**PLANNING COMMISSION
STAFF REPORT**

AGENDA ITEM: Planning File No. 225-18-MAJ: A Major Site Plan review for a proposed addition to the existing multi-family residential project

LOCATION: 219 Pitkin Street / Lots 22-24, Block 37, Frisco Townsite

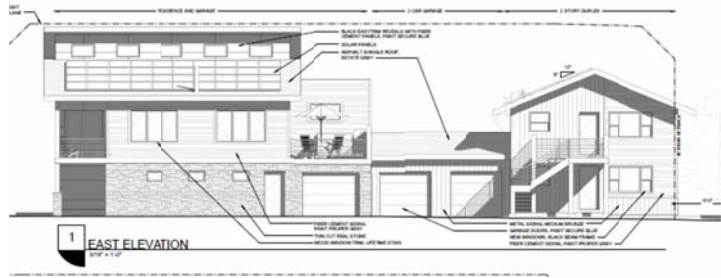
Three garage doors are recessed behind the front façade of the dwelling. The third garage door is not recessed behind the front façade but is in an existing location.

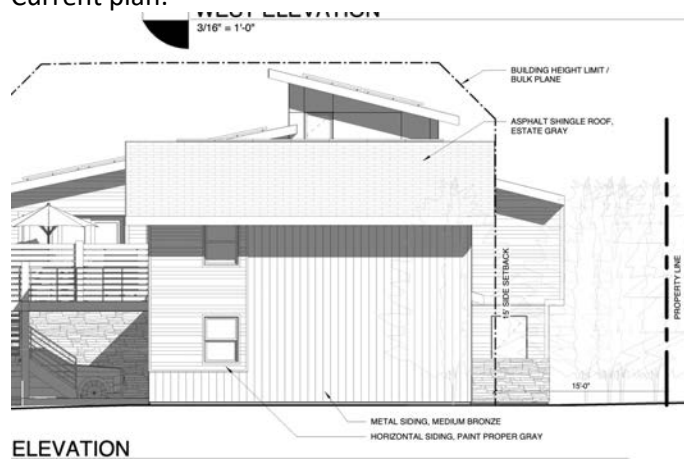
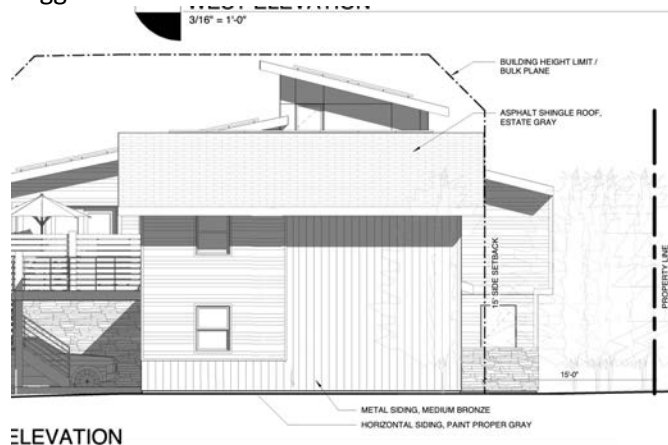
We are among a handful of neighbors who are viewing the property from the north side, with a property on Frisco Street Alley. As I view the plan, the plan on the north side of the property seems oddly out of balance. I am wondering about a minor revision to the plan, as included in the graphic below.

Certainly this is a matter of personal preference. My designer's eye happens to prefer the second view, and I decided to take up your offer to provide feedback. Thank you for the opportunity to do so. I look forward to welcoming this improvement to the property overall.
